Land at Bird in Eye Farm
South of Bird in Eye Hill
Uckfield

Planning Reference: WD/2021/2198/MAO

HIGHWAY NOTE

MT/5330/HN.2
November 2022

Proposed Site Access & Swept Path

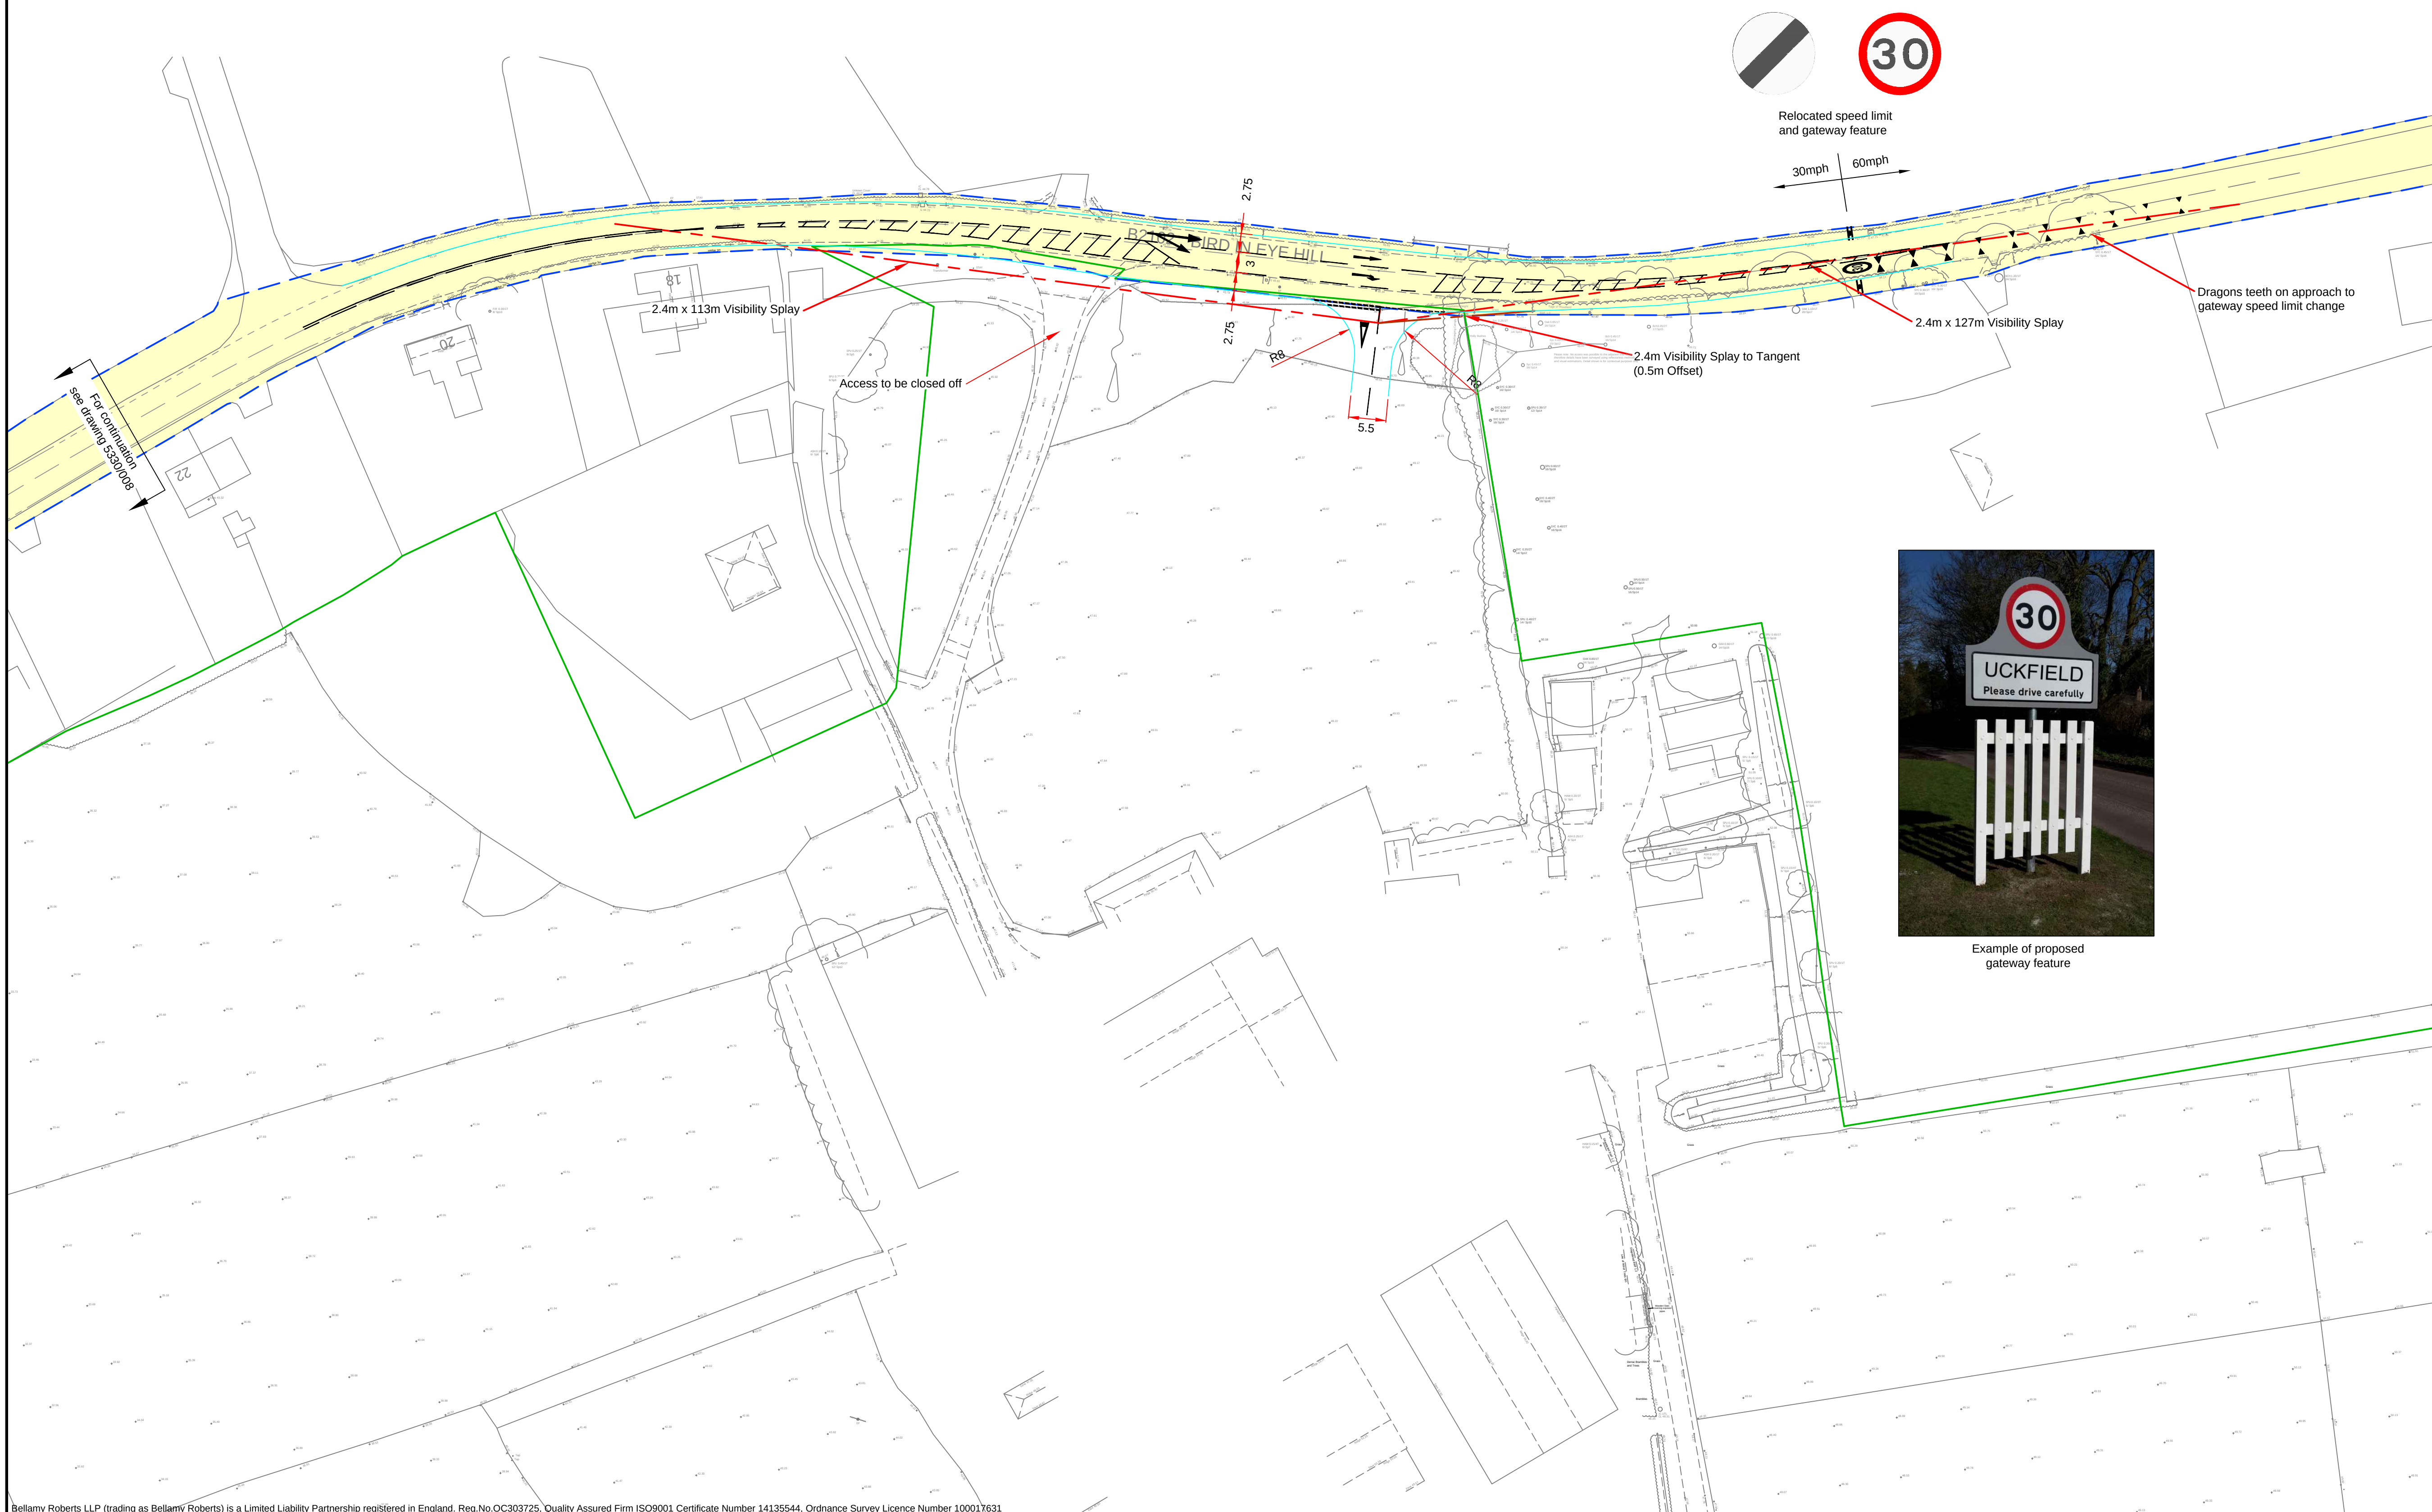
A.2.2	PROBLEM
Location:	Bird in Eye Hill
Summary:	Drivers approaching the proposed traffic island may not become aware of the feature at a safe distance
Acc Type:	Vehicle loss of control

The B2102 Bird in Eye Hill follows a number of bends in the road, is bounded by hedgerows in places and derestricted, therefore subject to the 60mph speed limit but according to the Audit Brief, observes 85th percentile speeds of up to 43.4mph. The proposals include the provision of a splitter island to the west to a proposed access and associated right turn lane. The scheme drawing illustrates that illuminated keep left bollards are to be provided which should highlight the feature to approaching drivers, however, due to the existing alignment of the carriageway as well as vegetation abutting the carriageway on the southern side, forward visibility for westbound drivers is limited. As such, there may be insufficient warning of the traffic island which could lead to vehicles striking the feature and loss of control type incidents.

RECOMMENDATION:	
It is recommended that sufficient forward visibility to the splitter island is achievable	
Location Plan:	
DESIGN ORGANISATION RESPONSE provided by Bellamy Roberts on the 2 nd Nov. '22 following formal issue of this Stage 1 Road Safety Audit on the 20 th Oct. '22	
<p>The 85th speed of westbound traffic approaching the existing bend in the road to the west of the proposed access and therefore the location of the proposed splitter island, equates to 42.6mph. The commensurate SSD of 114m is not achievable within either adopted highway or land under the control of the applicant. Whilst the proposed right turn lane will act as a traffic calming feature reducing westbound speeds on approach to the proposed splitter island, the future approach speed of traffic is not known. As such, it is proposed to replace the proposed island with lining as per diagram 1013.1 of the TSRGD to ensure that no vehicle approaching from the east will cross the centreline of the carriageway. See drawing 5330/021 rev. J.</p>
